Docket Item # 4
BAR CASE # 2011-0282

BAR Meeting
October 26, 2011

ISSUE: Request for concept review of three multi-family buildings in Phase V of the James Bland Redevelopment Project

LOCATION: 1000 First Street and 998 North Alfred Street

Figure 1. Proposed floor plans of multi-family buildings.

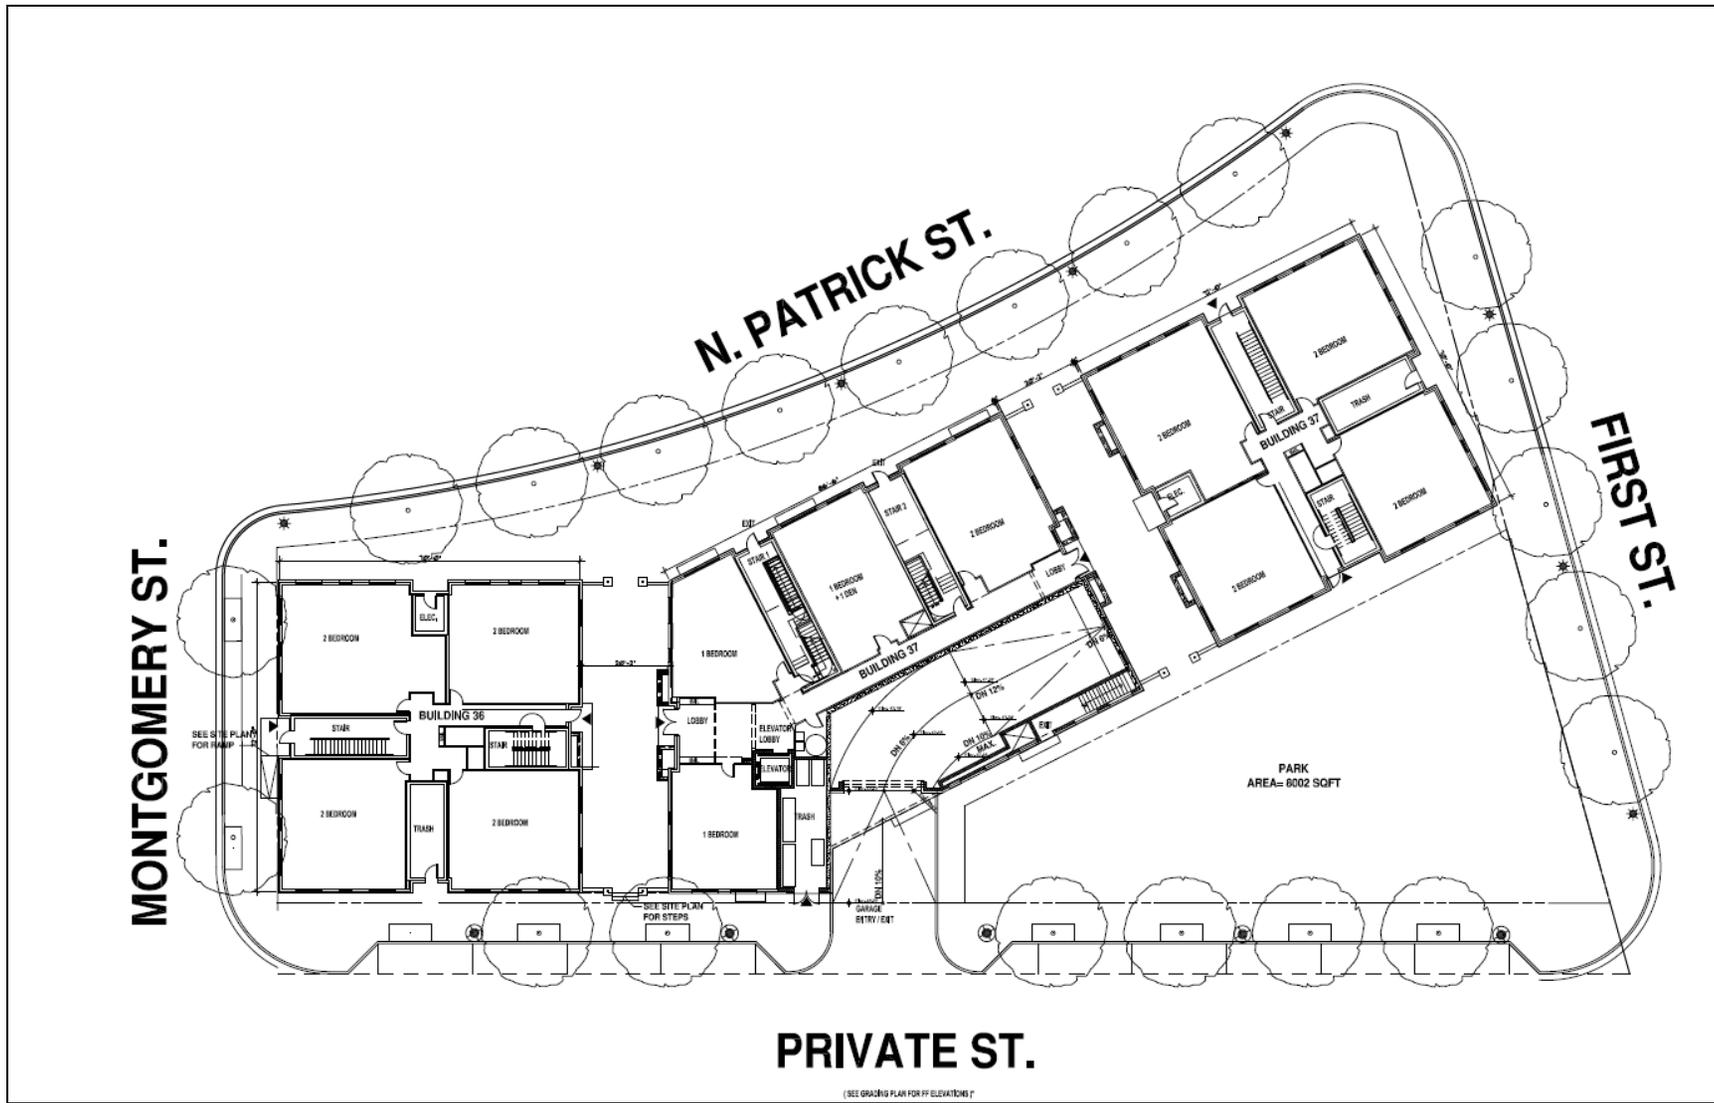
2. Refine the “hyphen” element on the northernmost building to make it as visually light as possible and to make the step down from four stories to three stories appear integrated.

The northernmost building has four stories of brick separated from a three-story section by a "hyphen" element clad in HardiePanel. This results in a step-down from the four-story section to the three-story section which is immediately adjacent to First Street and the boundary of this project.

Figure 3. Proposed west elevations (facing North Patrick Street).

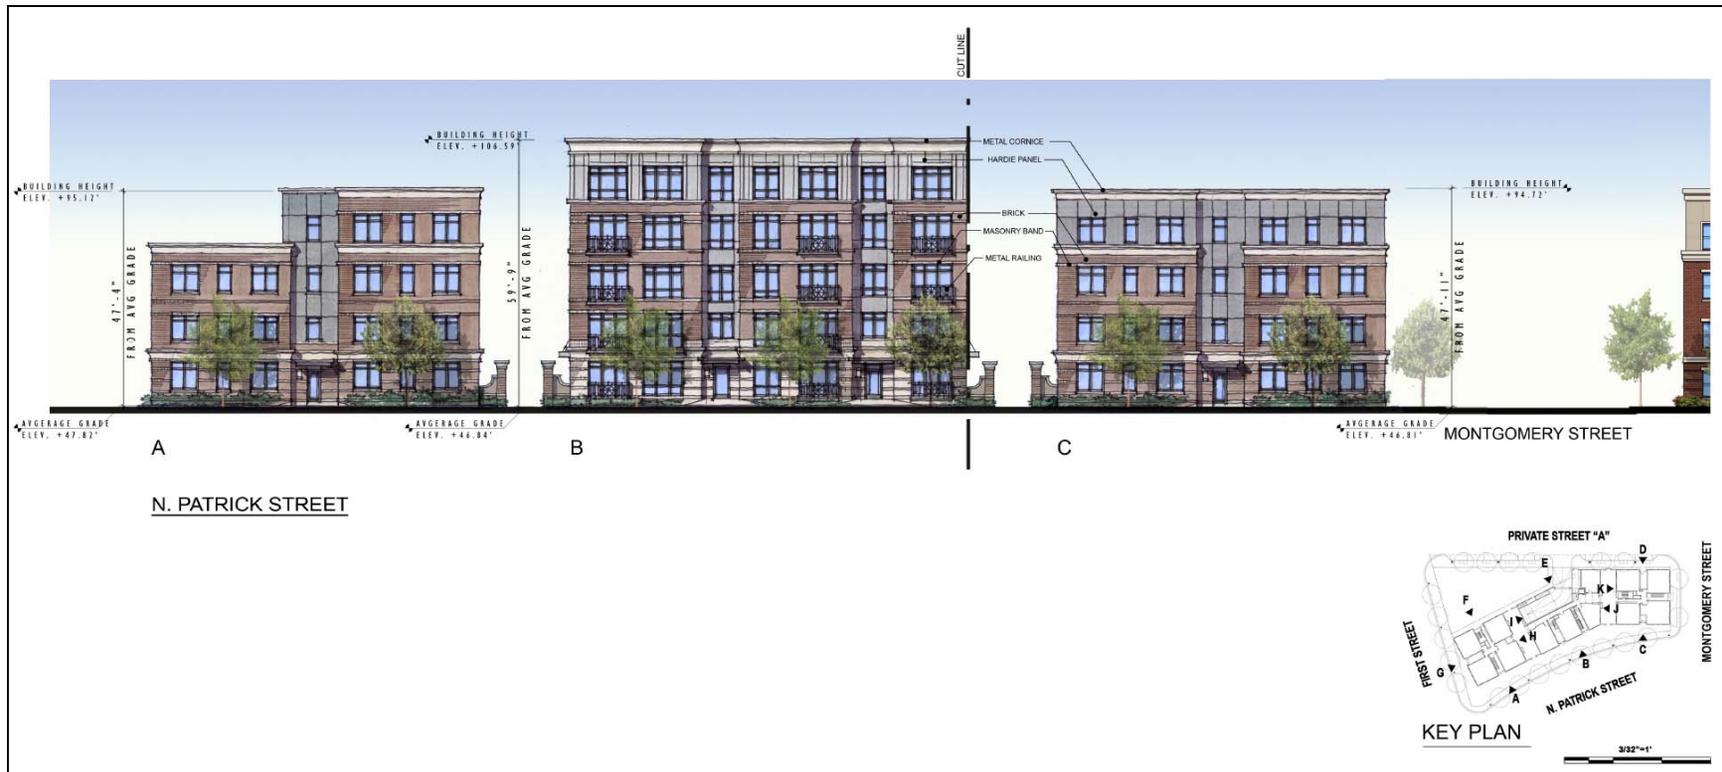
Staff has consistently supported the mass and scale of the four-story multi-family buildings finding them appropriate for the locations bordering North Patrick Street/Route 1. Staff supports the increase in height to five stories for the center building and notes that the proportions of this building are preferable as they result in a clearly defined "middle" in the classical form. Staff also finds the added height to be appropriate for a building of this size and in this particular location. In addition, Staff conceptually supports the idea of the northernmost building stepping

down one story to be more appropriately scaled with respect to the existing townhouses on First Street.
